7 INSTRUMENTATION AND CONTROLS

This chapter of the final safety evaluation report (FSER) documents the U.S. Nuclear Regulatory Commission (NRC) staff's (hereinafter referred to as the staff) review of Chapter 7, "Instrumentation and Controls," of the NuScale Power, LLC (hereinafter referred to as the applicant), Design Certification Application (DCA), Part 2, "Final Safety Analysis Report." The staff's regulatory findings documented in this report are based on Revision 5 of the DCA, dated July 29, 2020 (Agencywide Document Access and Management System (ADAMS), Accession No. ML20225A071). The precise parameter values, as reviewed by the staff in this safety evaluation, are provided by the applicant in the DCA using the English system of measure. Where appropriate, the NRC staff converted these values for presentation in this safety evaluation to the International System (SI) units of measure based on the NRC's standard convention. In these cases, the SI converted value is approximate and is presented first, followed by the applicant-provided parameter value in English units within parentheses. If only one value appears in either SI or English units, it is directly quoted from the D

Figure 7.2.7-1: Setpoint relationships during surveillance testing and calibration⁴

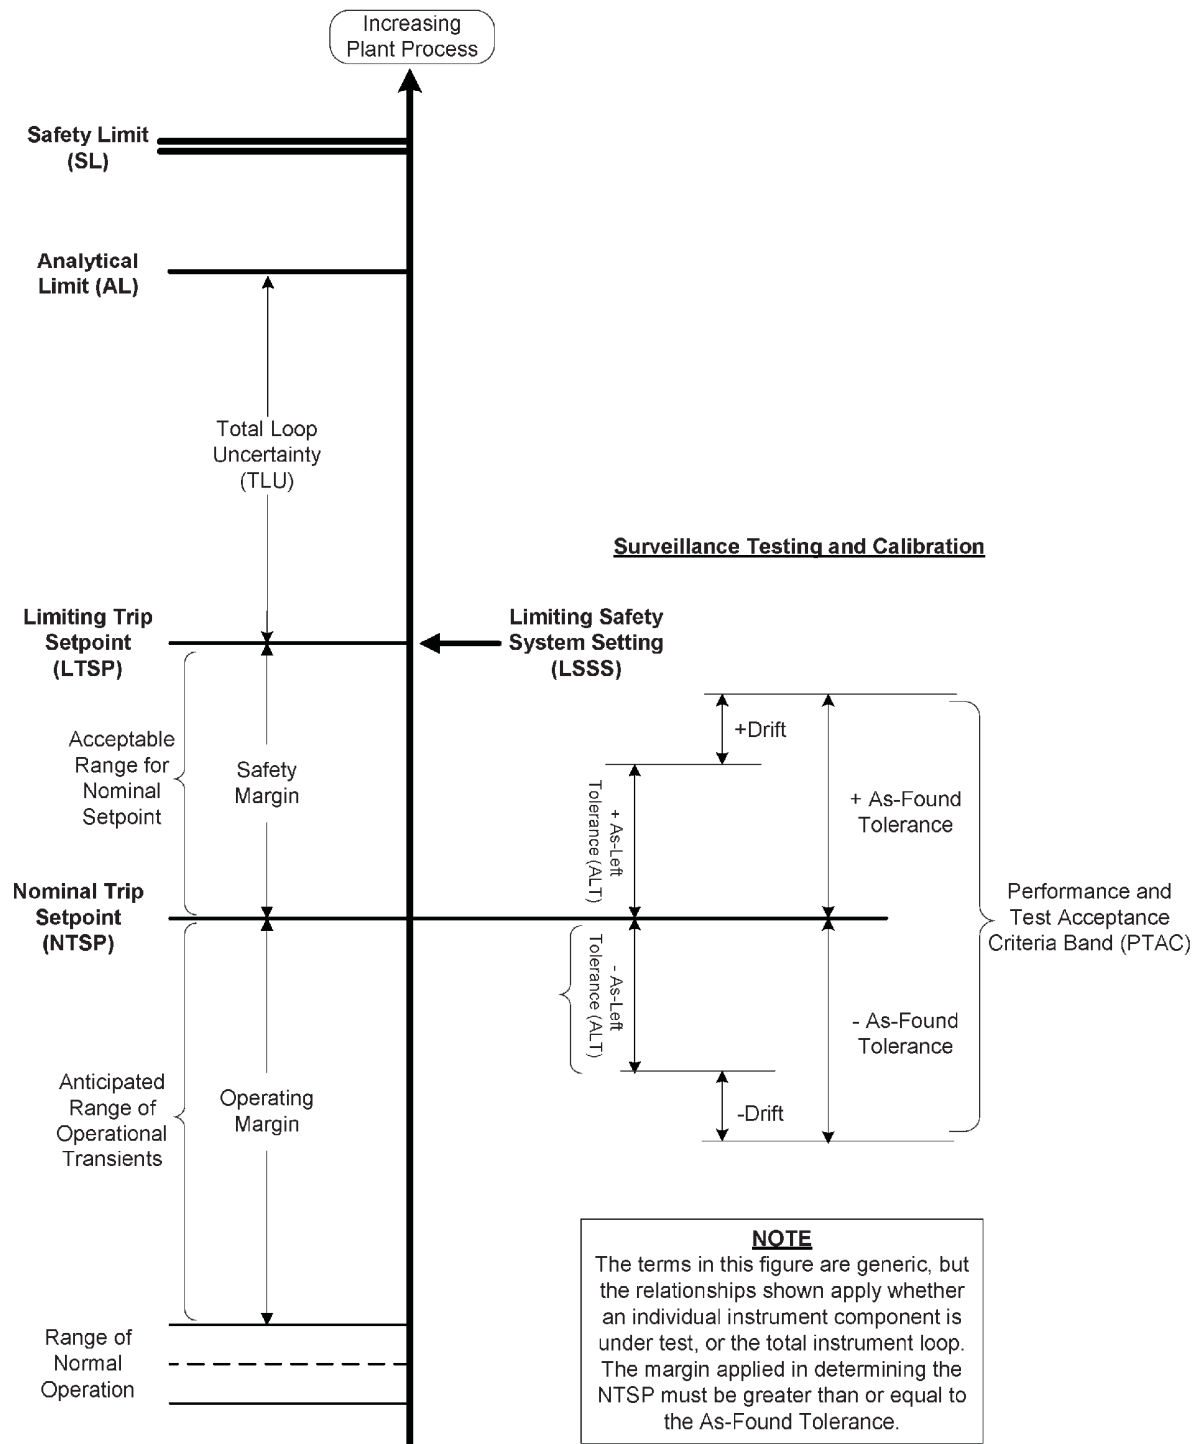
In the NuScale methodology, the AL is established to assure that a trip occurs before the SL is reached. The purpose of an LSSS is to assure that a protective action is initiated before the process conditions reach the AL. NTSPs are chosen based on the LSSS and to minimize spurious trips close to the normal operating point of the process. Figure 7.2.7-1 below provides a pictorial representation of the NuScale setpoint methodology relationships.

This figure is intended to provide relative position and not to imply direction. Sections 4.1.3 and 4.1.4 in TeR-0616-49121 define LTSP as an LSSS and also define NTSP as the desired value of
